# Access Compliance Report

## Public Rights-of-Way

### (Curb Ramps)

Intersection ID: 52452	Main Street: PAT_GARRETT_ST	Cross Street: BENDING_BIRCH_PL	Location: SE
ADA ID: 8A2915119D0C	Ramp Type: Directional1	Initial Pass/Fail: Fail	Overall Compliance: No
		Severity Score: 25

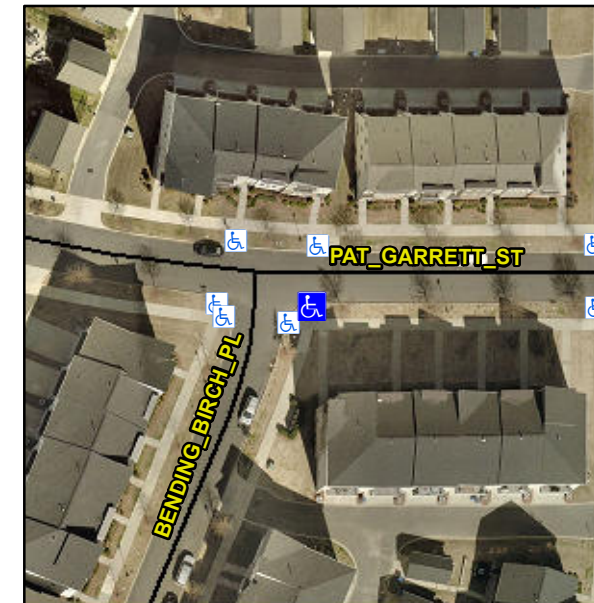
**HOLE IN GTR**

**R304.2.2, R304.5.3**

Compliance	Description	Data	Compliance	Description	Data
N/A	Ramp Length (in)	96.0	N/A	Grade Break?	N/A
Yes	Ramp Width (in)	64.0	N/A	Grade Break Slope (%)	0.0
No	Ramp Slope (%)	11.7	N/A	Grade Break XSlope (%)	0.0
No	Ramp XSlope (%)	5.5			
N/A	Flare Type LT	N/A	N/A	Flare Type RT	N/A
N/A	Flare Slope LT (%)	N/A	N/A	Flare Slope RT (%)	0.0
N/A	Flare Traversable LT?	N/A	N/A	Flare Traversable RT?	N/A
N/A	Landing Length (in)	0.0	N/A	DWS Provided?	N/A
N/A	Landing Width (in)	0.0	N/A	DWS Contrast?	N/A
N/A	Landing Slope (%)	0.0	N/A	DWS Length (in)	N/A
N/A	Landing X Slope (%)	0.0	N/A	DWS Full Width?	N/A
N/A	Landing Curb? (Y/N)	N/A	N/A	DWS Offset LT (in)	N/A
N/A	Shared Landing?	N/A	N/A	DWS Offset RT (in)	N/A
N/A	Gutter Ponding?	0.0	N/A	Gutter Slope (%)	N/A
N/A	Gutter Lip Ht (in)	3.0	N/A	Gutter X Slope (%)	N/A
N/A	Painted X Walk1?	No		Road Slope (%)	9.6
	X Walk 1 Direction	To N		Road X Slope (%)	1.3
	X Walk 1 Width (in)	N/A		Clear Space?	N/A

**Remove & Replace Entire Ramp.**
